## Frequently Asked Questions/Additional Information

### Accommodation at Gibraltar Point and Saltfleetby-Theddlethorpe Dunes National Nature Reserves, Lincolnshire

LINCOLNSHIRE WILDLIFE TRUST  
VOLUNTEER ACCOMMODATION

Title: DRAINAGE ALTERATIONS  
Dwg. No: 1065-04A  
Date: April 2022 Scale as shown  
Client: Lincolnshire Wildlife Trust  
Banovallum House, Manor Ho. St.,  
Horncastle, LN9 5HF

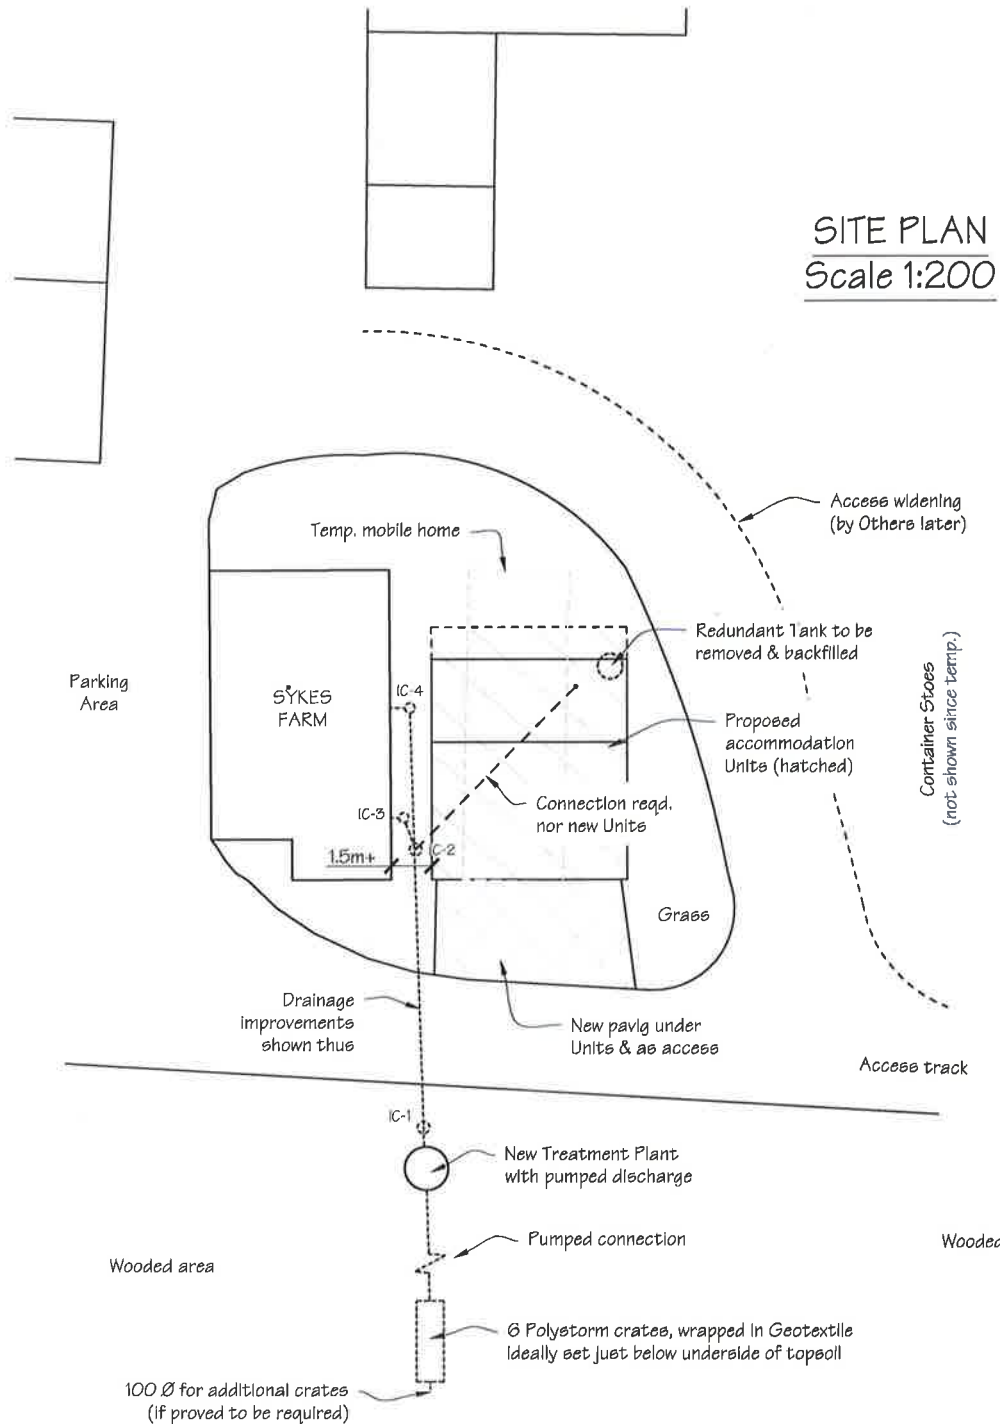
6. Drainage is annotated to be connected into existing system at Saltfleetby but Gibraltar Point is more vague; that suggests a new treatment tank. Is this just for the two nature reserve accommodation units being installed or to serve the existing properties? As it suggests the old one will be made redundant.

**See attached drawing 1065-04A for imminent upgrades planned for the foul drainage system at Gibraltar Point (this work, including removal of old septic tank, is being undertaken by others). A connection will, however, be required from the new units to IC-2.**
